# Intel<sup>®</sup> Quark<sup>™</sup> SoC X1000

Specification Update

*August 2014*

### 12.7.3.1 ECC Scrubber Configuration Register (P\_CFG\_50)—Offset 50h

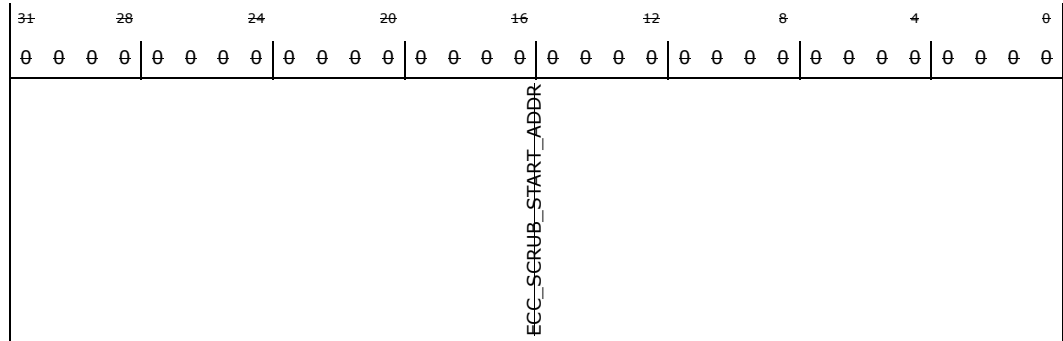
### 1. ECC Scrubbing Has Been Defeatured and is No Longer Supported on the Intel® Quark™ SoC X1000

Old Text: ECC Scrubber Registers (Offsets 50h, 76h, 77h, 7Ch) have been removed.

New Text: Section 12.3.1 ECC Scrubbing has been removed.

#### 12.6.2.1 SPI DMA Count Register (SPI\_DMA\_CNT\_IOSF) — Offset 0h

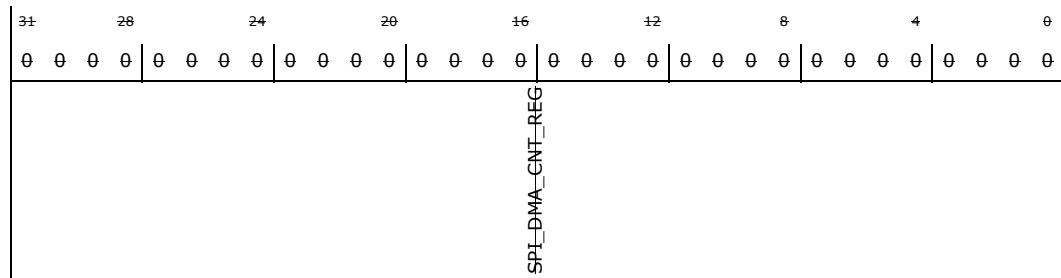
## 2. Remote Management Unit DMA via IOSF Primary is No Longer Supported on the Intel® Quark™ SoC X1000

Issue: The Intel® Quark™ SoC X1000 uses only the sideband option for setting up a DMA transfer.

New Text: Section 12.6.2 has been removed.

#### 12.6.2.3 Option Register 1(P\_CFG\_72) —Offset 72h

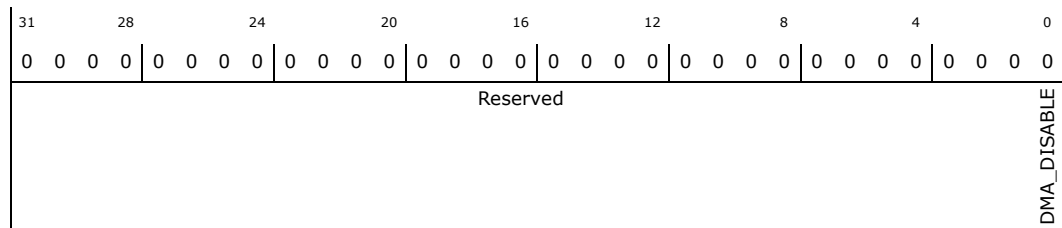
### 3. Lock Out DMA Capability Past Boot

Issue: DMA functionality must be disabled on boot completion to prevent an attacker from using it to take control of the system.

New Text: A new register is added:

Bit Range	Default & Access	Field Name (ID): Description
31:1	0 RO	<b>Reserved (RSVD):</b> Reserved.
0	0 RW	<b>DMA_DISABLE:</b> Remote Management Unit DMA disable. Once set RMU DMA functionality is disabled until system reset

Figure 1. Transmit Descriptor Fields

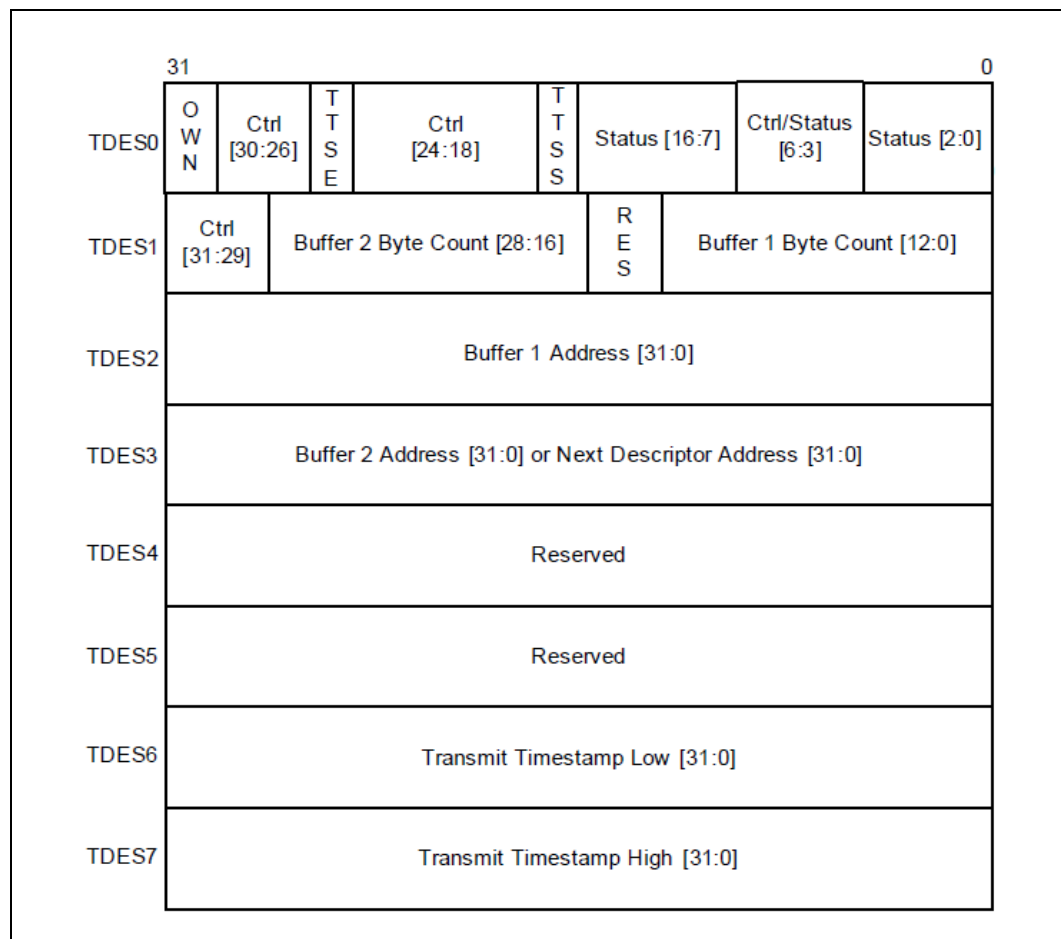
### 2. Additional Details about MAC Descriptors

Issue: Revision 001 of the Intel® Quark™ SoC X1000 Datasheet describes MAC registers in Section 15.6, however, details of the MAC descriptors are not included. The information in [Appendix A, "MAC Descriptor Details"](#) will be added to a future revision of the datasheet.

The transmit descriptor structure is shown in Figure 1. The application software must program the control bits TDES0[31:18] during descriptor initialization. When the DMA updates the descriptor, it writes back all the control bits except the OWN bit (which it clears) and updates the status bits[7:0]. The contents of the transmitter descriptor word 0 (TDES0) through word 3 (TDES3) are given in Table 1 through Table 3, respectively.
